## ANN ARBOR HISTORIC DISTRICT COMMISSION

### Staff Report

**ADDRESS:** 207 W. Jefferson Street, Application HDC10-142

**REPORT DATE:** November 10, 2010

207 W. Jefferson South Elevation - Proposed Basement Egress Window

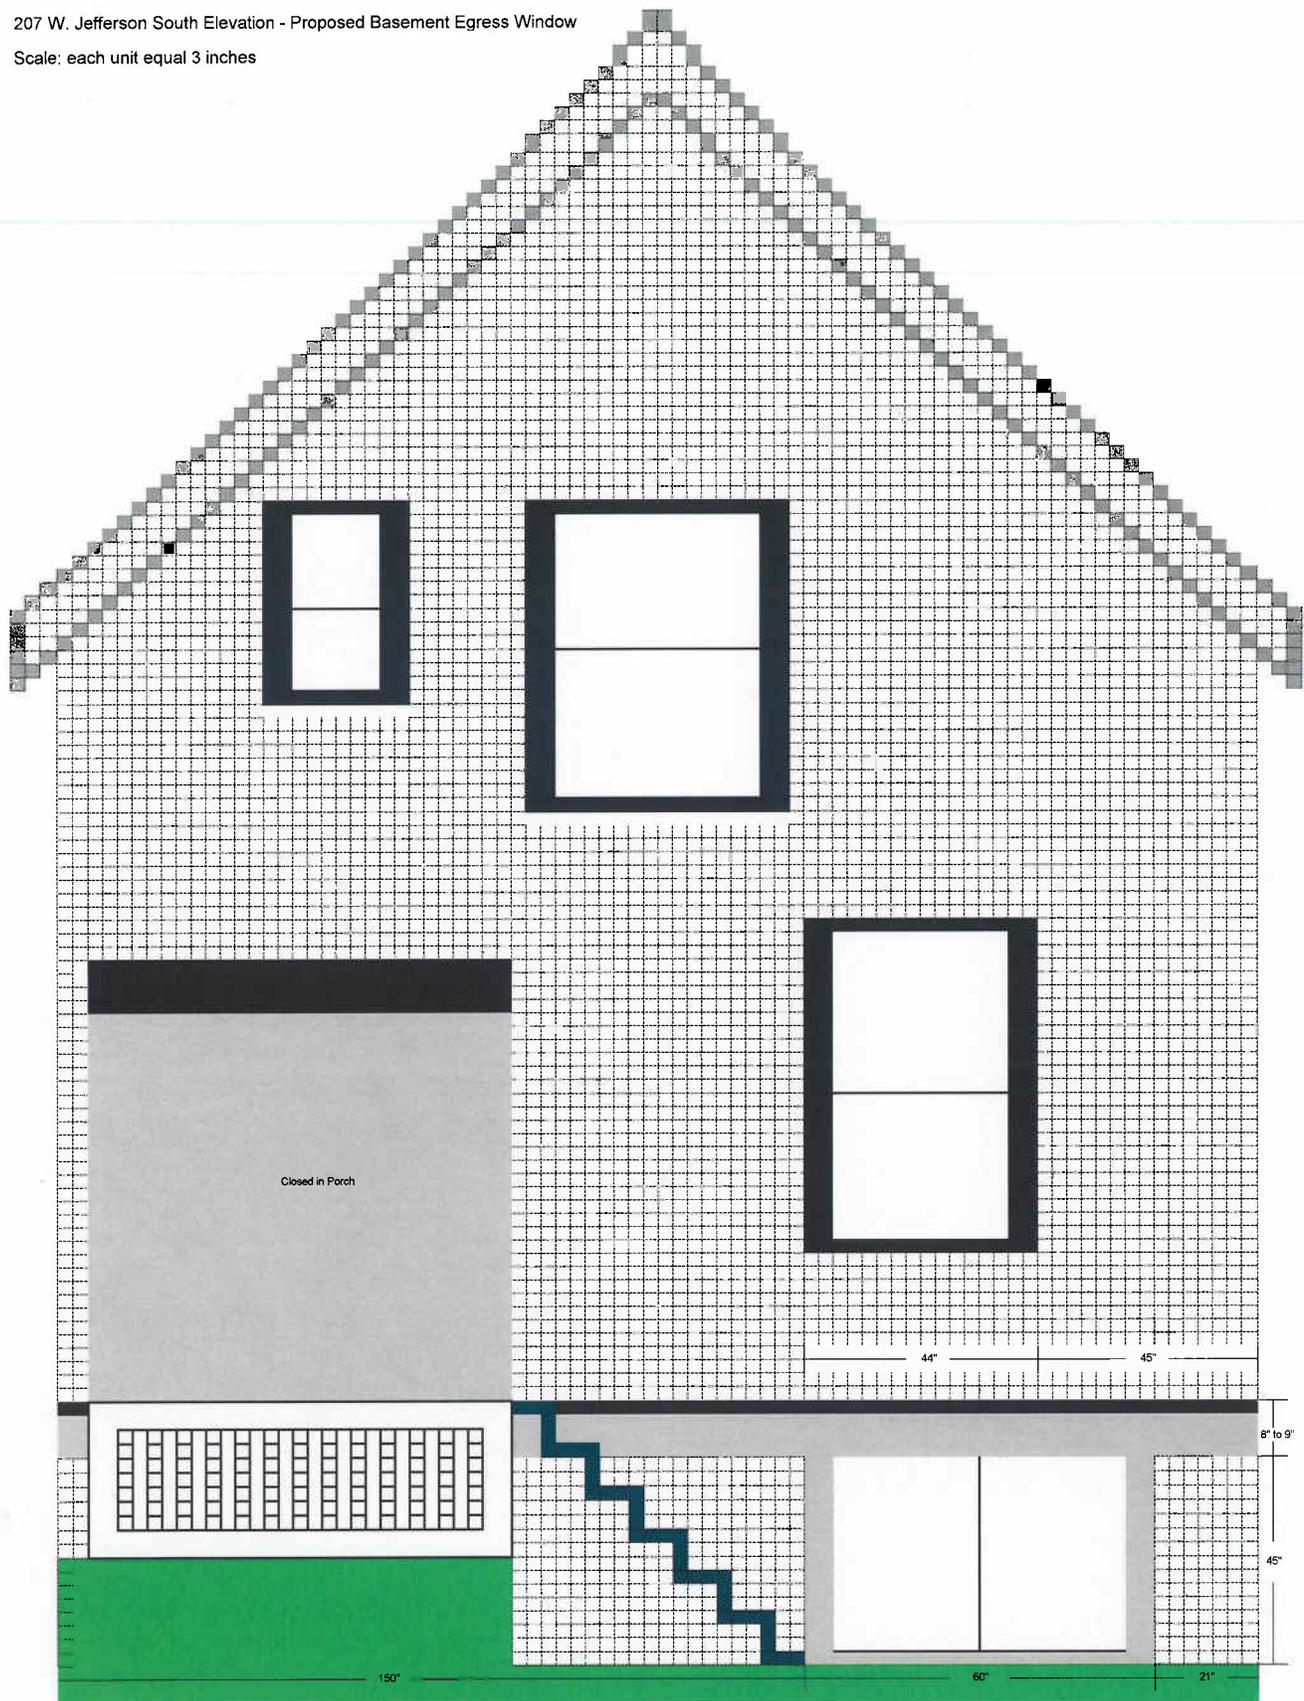
1. At their September, 2007 meeting, the HDC determined that the size of the existing egress window is out of proportion with the other windows and features of the house, and that the work negatively impacts the east character-defining elevation of the house. Staff

feels that relocating this window to the rear elevation would be similarly inappropriate. Despite the rear elevation having a lesser visual impact on the structure as a whole, the window is still disproportionate to other windows on the house. In addition, the existing window cuts into the baseboard, which is incompatible with the building, and no indication has been given that the same would not be true if the window were relocated to the rear elevation. The window also does not match the two taller-than-wide egress windows approved for the east elevation, and the necessity of a third basement egress window has not been demonstrated.

I move that the Commission deny the portion of the application to install an egress window on the rear elevation of the house. This proposed work is not compatible in exterior design, material, and relationship to the rest of the house and does not meet *The Secretary of the Interior's Standards for Rehabilitation* and *Guidelines for Rehabilitating Historic Buildings*, in particular standards 2 and 9.

207 W. Jefferson Driveway, Patio & Storage Shed Proposal

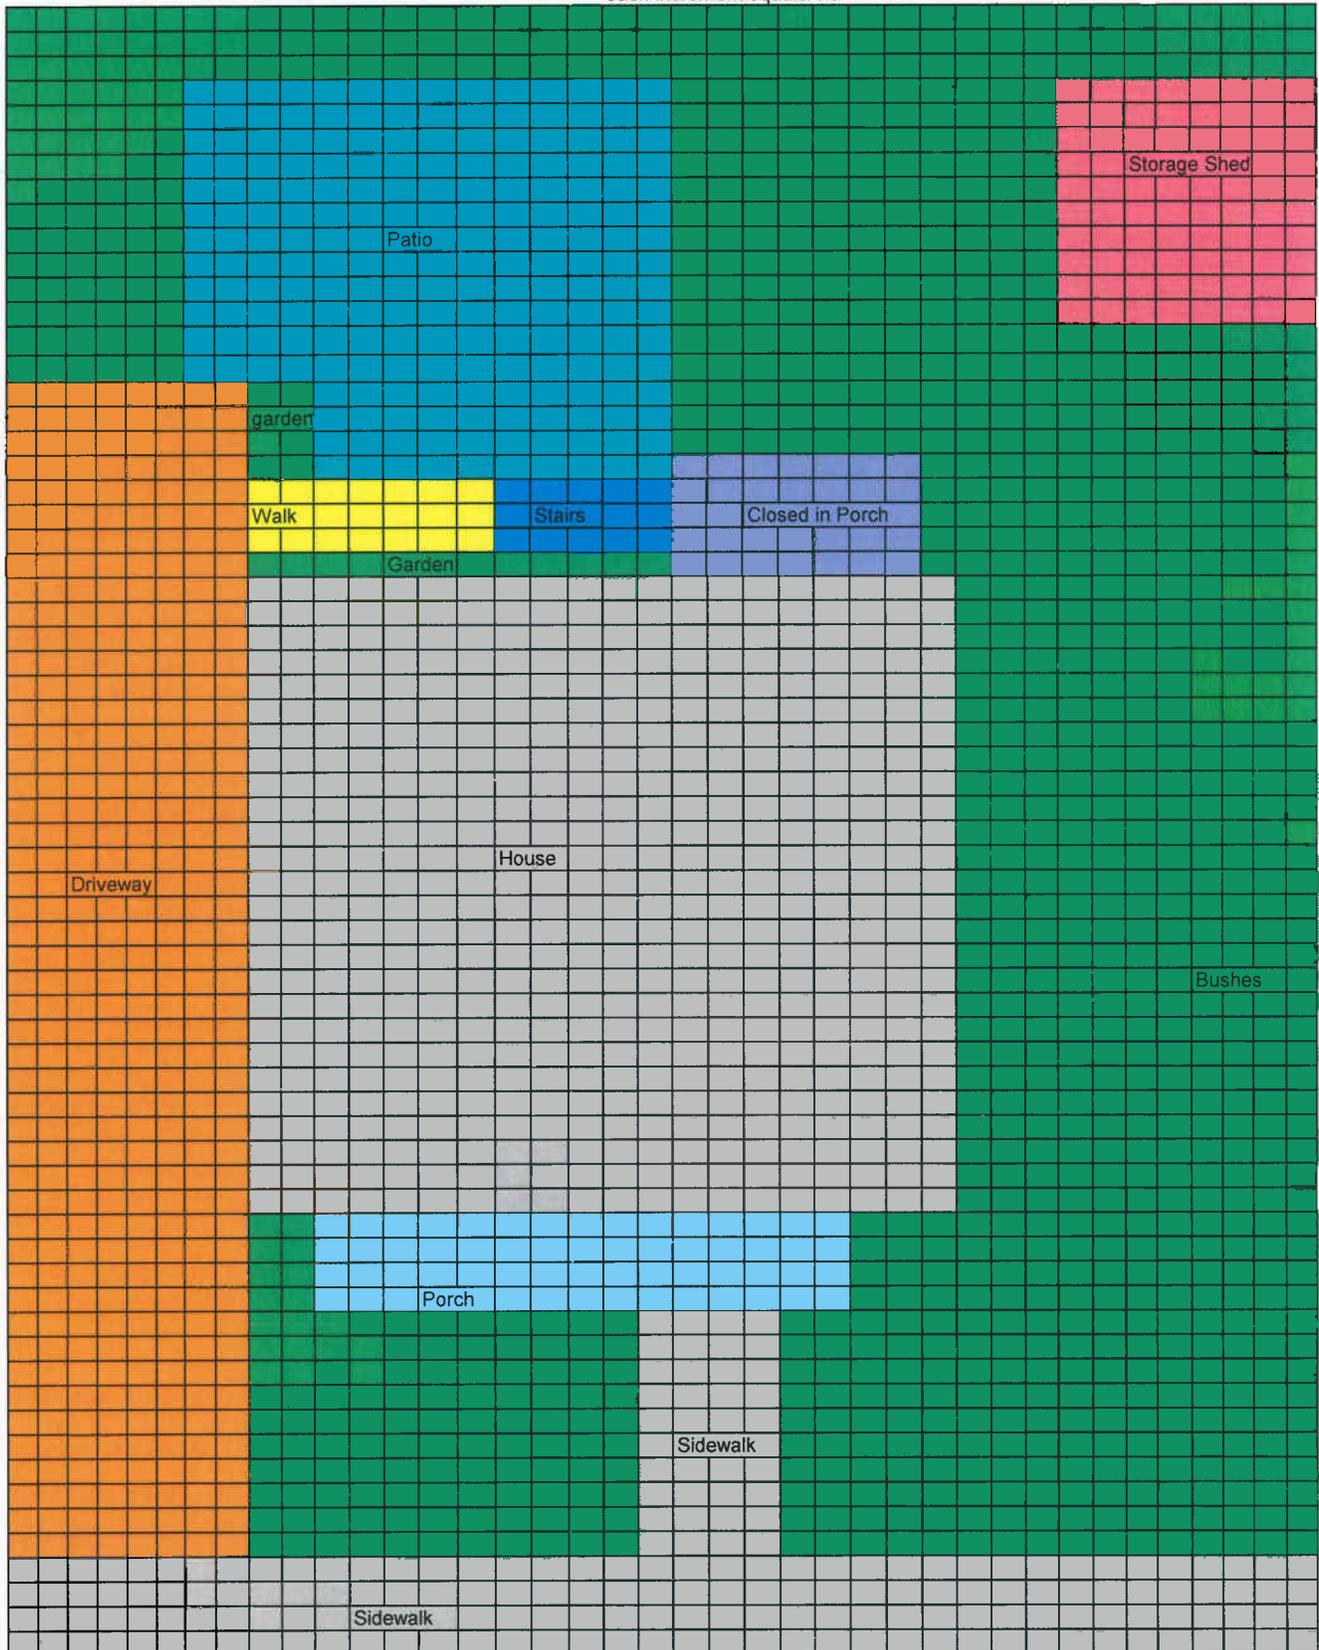
2. The eight foot wide concrete driveway fills the east side yard from the property line to the house, per the application drawing. In the January 2009 staff report it is noted that the two egress windows approved along the driveway appear to extend 3" to 5" below grade. If the driveway paving is approved, staff will continue to work with the applicant and the Building Official to insure that any well or clear area required for the egress windows meets building, zoning and HDC standards. If any additional curbs, bollards, or similar are required by the Building Official to delineate the window well or driveway, a new application will need to be submitted to the HDC.

3. The storage shed would need to move three feet away from the west property line to meet zoning setback requirements. The size, materials, and design of the shed are simple and appropriate, as is its placement in the rear corner of the lot. The materials and size of the patio are appropriate.

I move that the Commission issue a certificate of appropriateness for the portion of the application at 207 West Jefferson, a contributing property in the Old West Side Historic District, to install a shed, patio, and concrete driveway, on the condition that permits are not issued for the new work before the basement egress window on the east elevation is replaced per application HDC08-068. As conditioned, this proposed work is compatible in exterior design, arrangement, texture, material and relationship to the rest of the house and the surrounding area and meets *The Secretary of the Interior's Standards for Rehabilitation* and *Guidelines for Rehabilitating Historic Buildings*, in particular standards 2,5, and 9.
